Section 00 63 63 - CHANGE ORDER NO. 1

Owner:	City of Racine, Wisconsin	Owner's Project No.:	W-21-1
Engineer:	Dixon Engineering, Inc.	Engineer's Project No.:	49-59-09-04-21
Contractor:	General Construction Services	Contractor's Project No.:	
Project:	2,750,000 Gallon Standpipe		
Contract Name:	Roof Replacement		
Date Issued:	August 5, 2021	Effective Date of Change Order:	August 5, 2021

Racine, WI 2,750,000 Standpipe	
Roof Handrail	
Drawn By: TMF	Date: 08/04/21
Checked By: JVR	DWG: 01

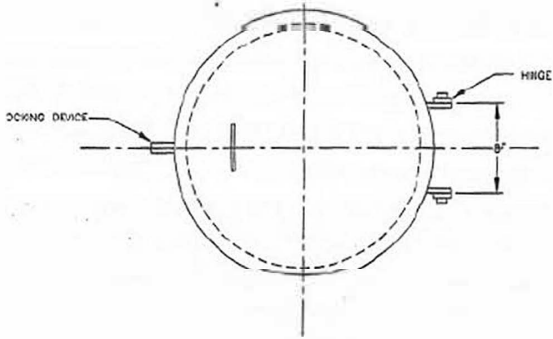
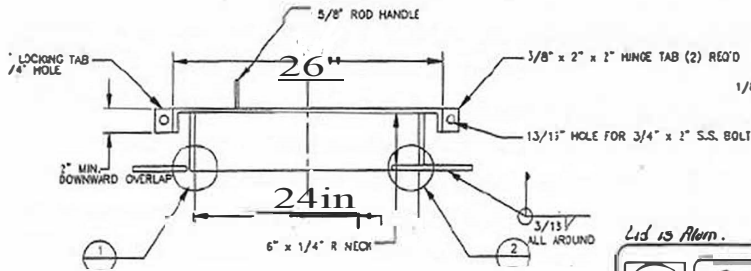
Description: Install the roof handrail per the attached drawing and install 3 manways outside the handrail per the attached drawing. Each manway is to have a gasket installed on the cover per the specifications (per section 05 00 00 part 3.05E)

- NOTES:**
- HANDRAIL AND POST ARE TO BE CONSTRUCTED OF 3" x 3" x 1/4" STRUCTURAL STEEL ANGLE. POST BASE PLATES ARE BE 6" x 6" x 1/4" STEEL PLATE. MIDRAIL SHALL BE 3" x 3" x 1/4" STRUCTURAL STEEL ANGLE. ALL WELDS SHALL BE 3/16" CONTINUOUS FILLET WELDS; ALL AROUND.
 - SPACING BETWEEN MOUNTING PADS IS NOT EXCEED 6'. IT MAY BE NECESSARY TO USE MORE THAN THE NUMBER OF PADS SHOWN.
 - AN OPENING IS TO BE MADE IN THE HANDRAIL IN THE FIELD FOR THE ROOF LADDER. CONSTRUCT THE HANDRAIL IN THE SHOP THEN MODIFY IN THE FIELD.
